Pre-Hearing Ground Water Discharge Plan Analysis

MT. TAYLOR URANIUM MILL PROJECT
GULF MINERAL RESOURCES COMPANY

Ground Water Section
Water Pollution Control Bureau
New Mexico Environmental Improvement Division

September, 1980

FIGURE 3
MILL PLOT PLAN

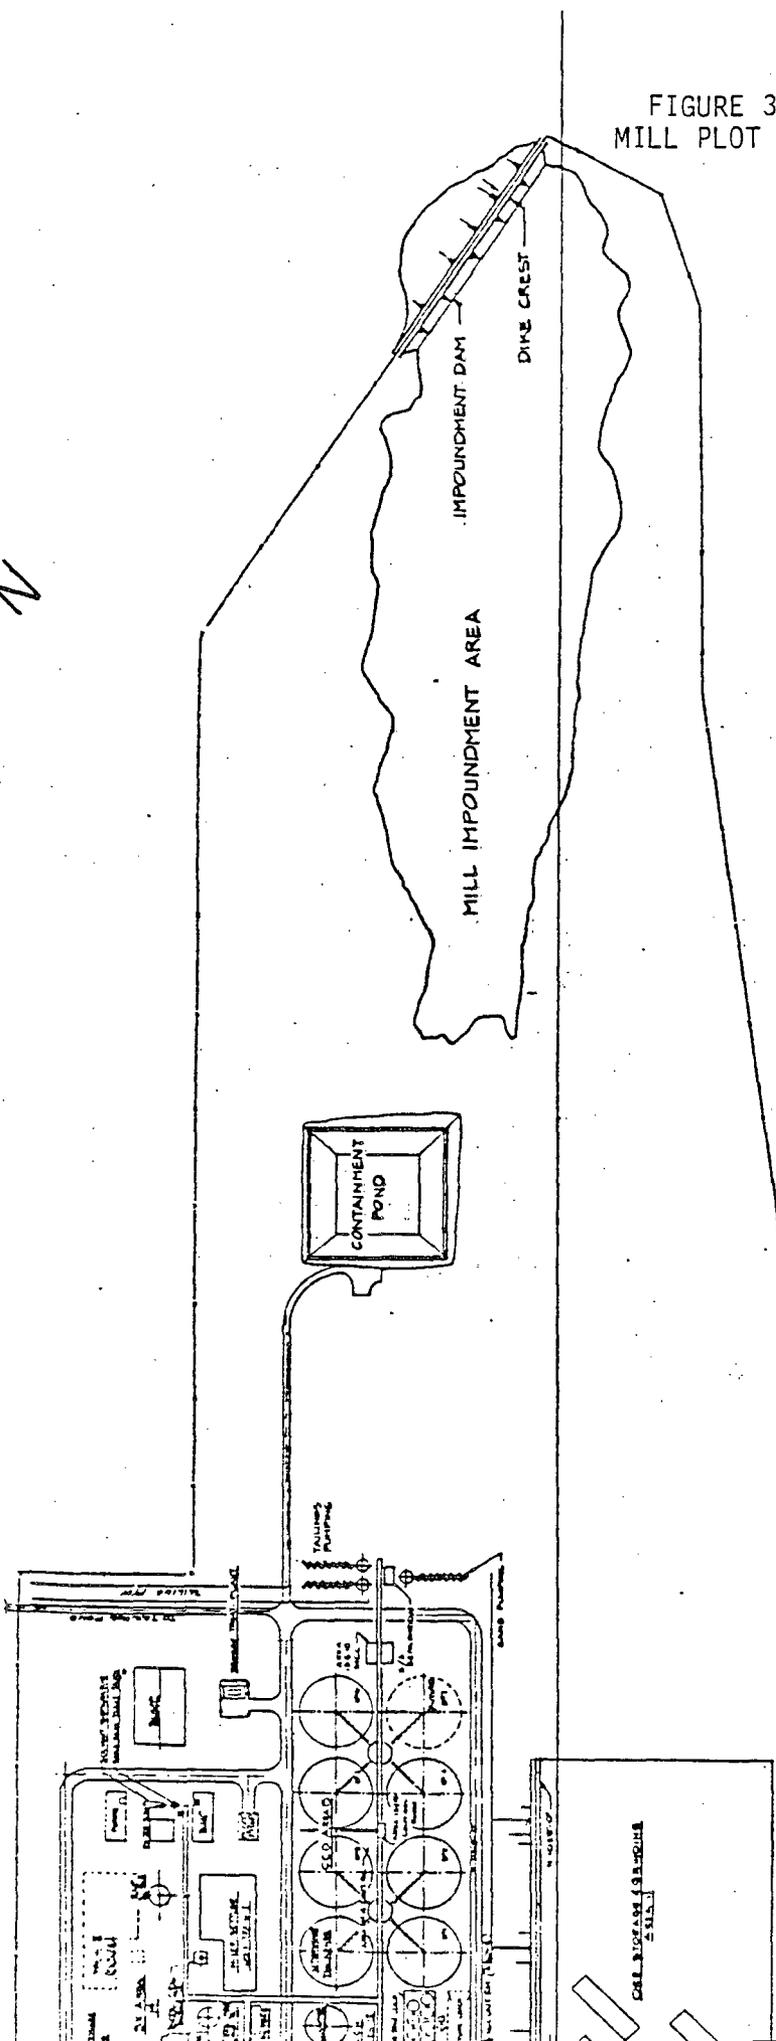
Our analysis of the site's geology and hydrology and of the engineering concepts and designs incorporated into the containment pond and mill impoundment generally supports Gulf's conclusion that minimal impacts to ground water should result from these structures. This is based upon the following key factors:

1. Planned discharges at the mill site, e.g., process area washdown water and sewage water, will be relatively low in volume. Except during periods of extraordinary precipitation, sufficient freeboard should exist in the containment pond to contain any major process spillage. Contaminated releases to the mill impoundment area, therefore, are seen to be infrequent.

2. The containment basin is proposed to be lined with 20 mil PVC plus 12 inches of earth and basin so that migration of liquid from the pond into the underlying strata will be minimized. The PVC is chemically compatible with the acidic mill waste, while the earth cover will greatly reduce ozone and ultraviolet radiation weathering effects on the lining.

4. Examination of available drilling information and of on-site hydrogeologic features supports the applicant's interpretation that a limited perched zone of saturation exists in the alluvium near the mill site. Monitoring of the perched zone, however, seems appropriate because surficial features suggest that the alluvial ground water system becomes more extensive north of the mill impoundment. This is being accomplished via an open-well piezometer near the containment pond. Seepage into the alluvium from the mill impoundment should be minimal due to the positive cutoff trench and grout curtain within the dam. Open-well piezometers within the dam should allow for detection of significant seepage to the alluvium from the impoundment.

In summary, the applicant's proposed ground water pollution protection design for the mill facility is considered to be satisfactory to meet the NMWQCC Regulations.

FIGURE 5
TAILINGS PIPELINE CROSS SECTION

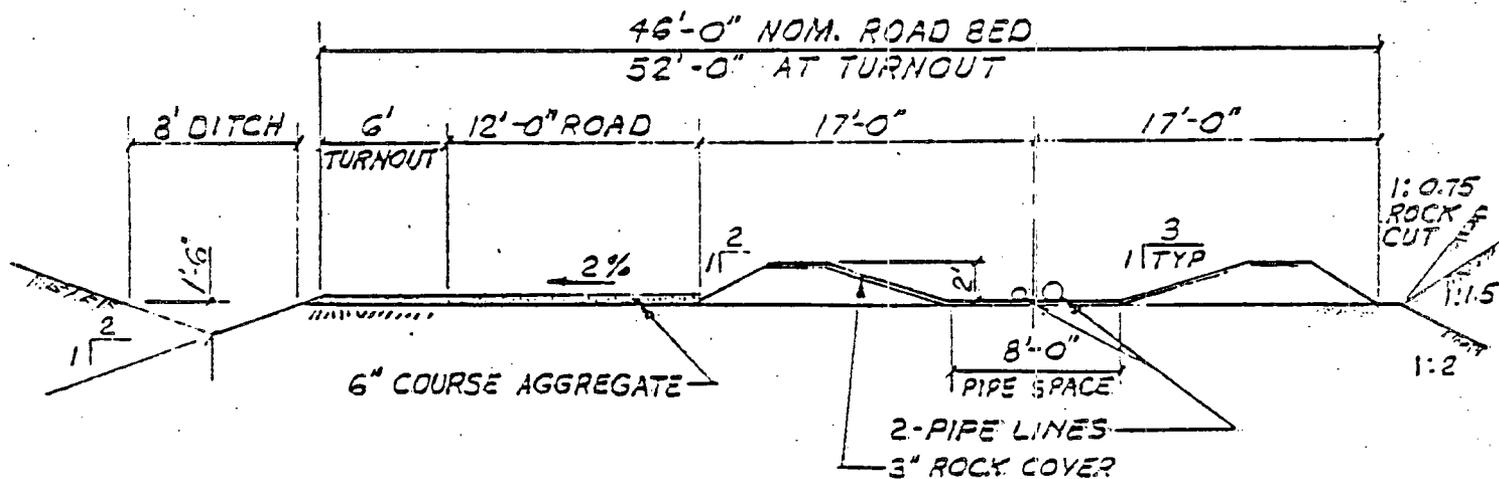
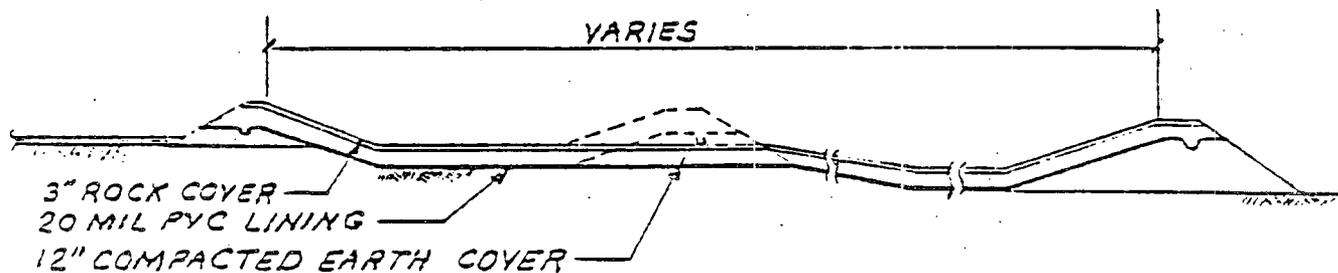
Regarding the discussion of a possible tailings pipeline rupture, the applicant has presented a generally realistic, albeit oversimplified, evaluation of the resulting water quality impacts. The discussion focuses on three processes to reduce the contaminant levels to acceptable limits: dilution of the contaminant stream by mine water conducted in San Lucas Wash; moisture deficits in the surficial soils which would impede rapid infiltration of the waste to the water table; and geochemical attenuation of the percolate, principally by pH change and adsorption. The staff feels

that dilution provides a reliable attenuation mechanism for the waste discharge. Complete transverse and vertical mixing would occur quickly in the stream. Geologic conditions downstream would tend to encourage relatively uniform stream bottom recharge rates; this should result in recharge of a thin, narrow and elongate, horizontal tabular slug of the diluted waste stream. Continual recharge of treated mine water into the shallow ground water system will provide for further moderation of the contamination. Primary reliance should not be placed on moisture deficits or on geochemical processes for attenuation of the spillage, as their potentials remain speculative without further quantification.

In summary, it is our opinion that the applicant's proposed pipeline system design is acceptable. It is believed that the redundant instrumentation and frequent inspection schedules will virtually eliminate any possibility of accidental spills adversely affecting ground water quality. Assuming a major release of tailings via pipeline rupture, it is unlikely that ground water standards would be violated at a place of foreseeable use.

FIGURE 12
CONTOUR MAP OF SEEPAGE FRONTS WITH TIME

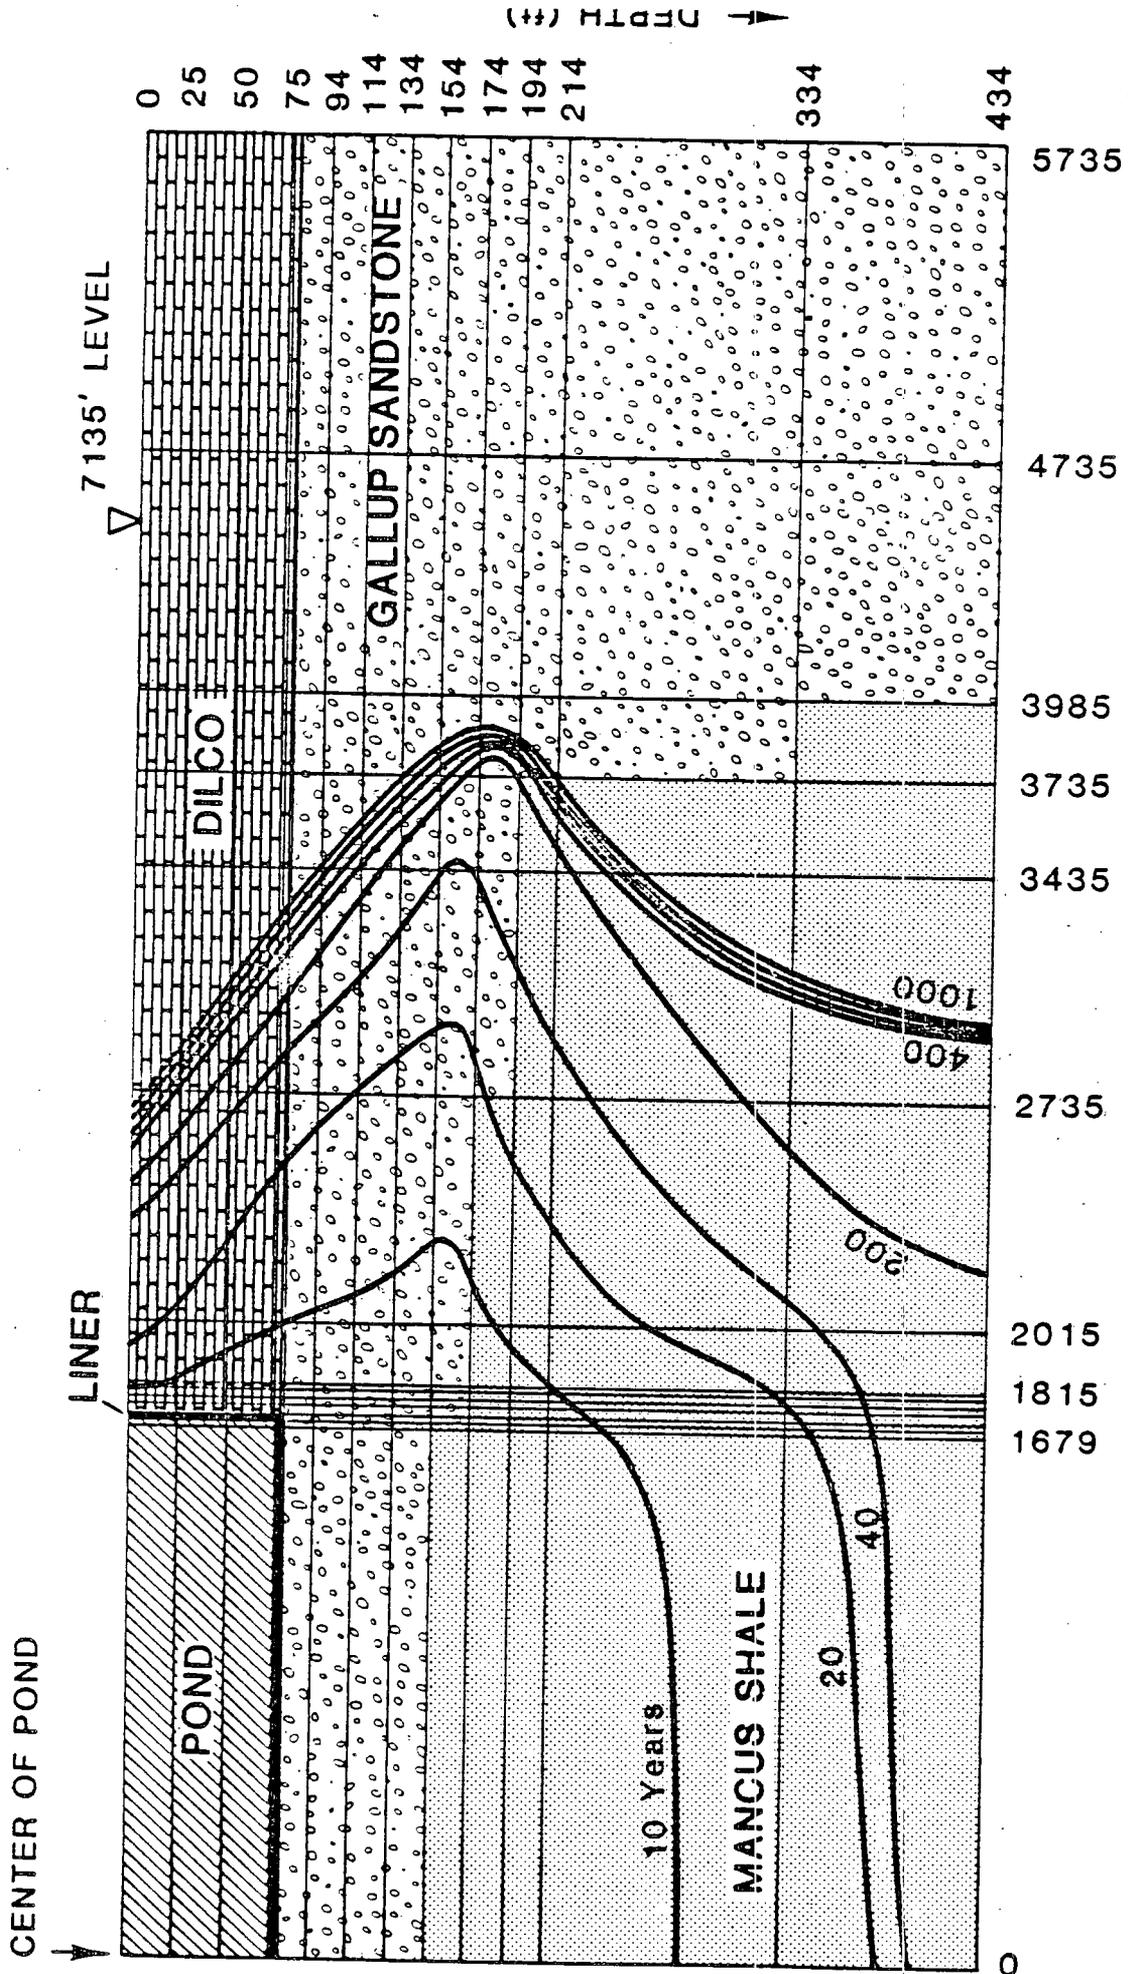
Figure 12 illustrates the evaporation pond configuration and cross-section of the surrounding rocks assumed for the initial two-dimensional modeling effort and illustrates the calculated seepage front movement. The total 204 acres of the pond bottom was assumed to overlie the Gallup Sandstone with only a three-foot thick liner between them. In reality, only 118 acres of the Gallup form part of the pond base with the remainder being formed by the less permeable Dilco unit. Other assumptions which should favor a high seepage, compared to the actual physical system, included: the assumption of a constant water depth throughout the year, as specified for the end of the year; and the assumption of a flat bottom for the pond, instead of the actual sloping bottom which would increase the seepage area and the potential difference between the pond and the underlying formations. Rock properties assumed for the simulation are presented in Table 2.

Using those properties and assumptions, the simulator calculated that approximately 7,254 acre-feet of water would seep into the formations from the pond, more than double the volume predicted by the one-dimensional model. In Figure 12, the seepage front movement is tracked by plotting the zero saturation-change contours. The right-hand side of the seepage front contours represent rock formations that undergo no change in water saturation or no contamination by seepage water at the time indicated on the contour. These contours indicate that the rate of advance of the seepage fronts significantly decreases after about 400 years of simulation and is essentially stationary at the end of 1,000 years. The calculated seepage front has become essentially immobile 3,800 feet radially from the center of the pond and thus should not impact ground water.

FIGURE 13

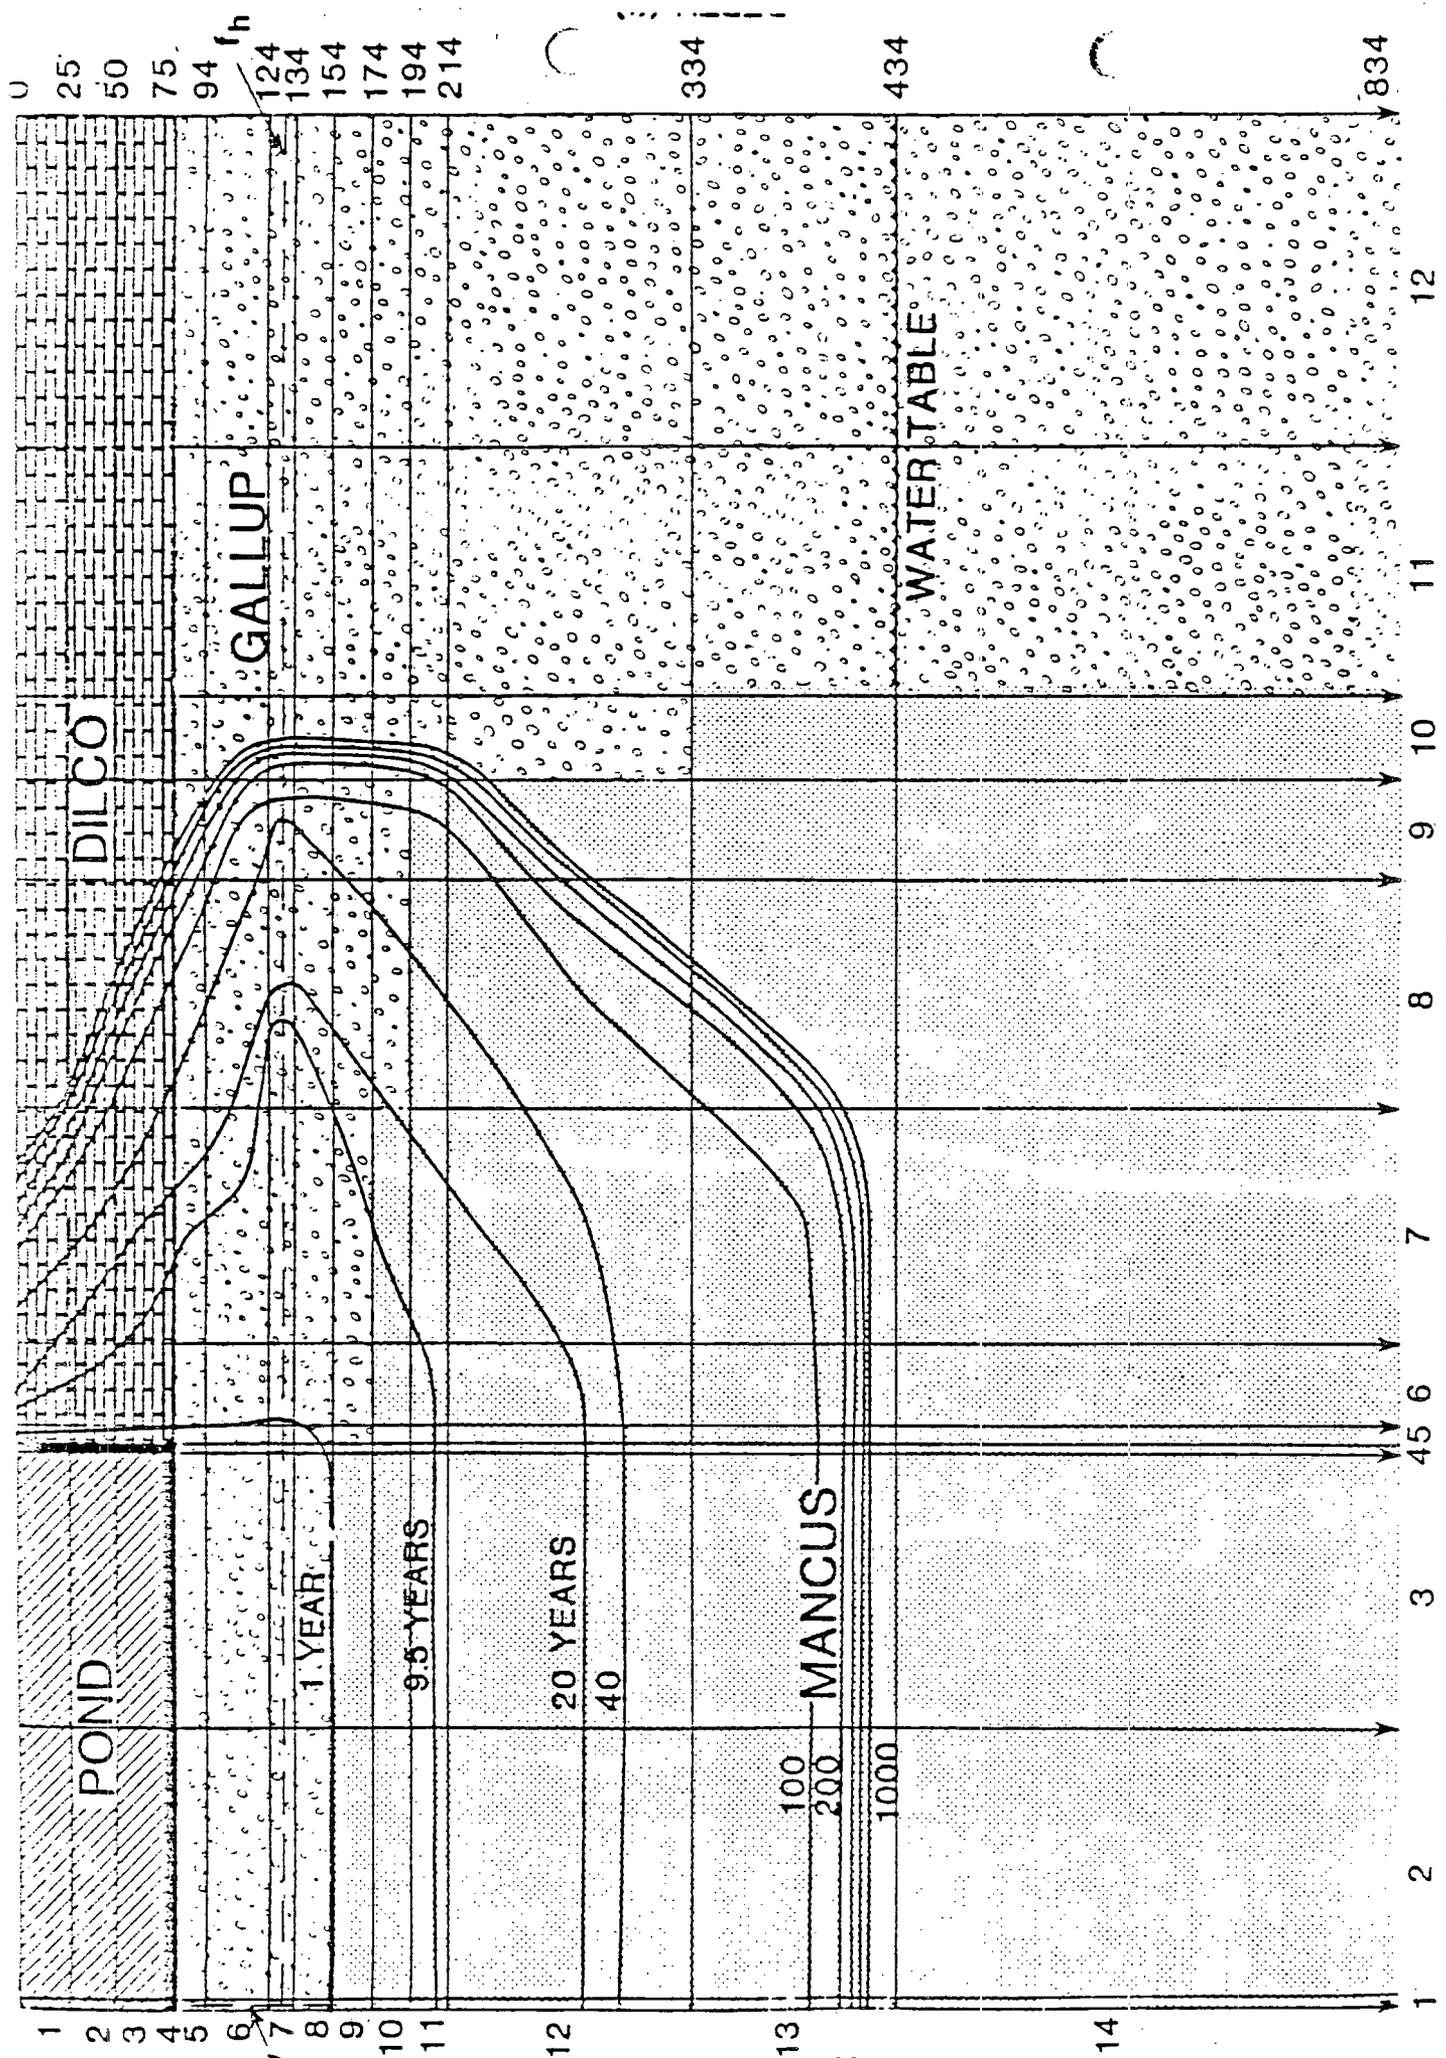
An important consideration in the use of a two-dimensional computer model is how one discretizes the area of concern. The discretized cross-section of the pond and of the surrounding rocks used in the initial simulation is shown in Figure 12. Each of the rectangular blocks shown in this figure are ring-shaped and are extended over 360° around the vertical axis through the center of the pond. The rings are assumed to have uniform rock and fluid properties. However, each of these blocks are assigned a fixed value for porosity and permeability according to the geologic formations they represent. Considering the complexities in mathematical simulations and in the variabilities in rock properties, it follows that the finer the discretization (mesh) used, the more accurate will be the results.

Our review of the initial simulation raised questions regarding the mesh size chosen, and regarding the dimensions of the cross-section chosen for discretization. Our particular concerns were:

The accuracy of the model is judged to be sufficient, given the revised grid mesh.
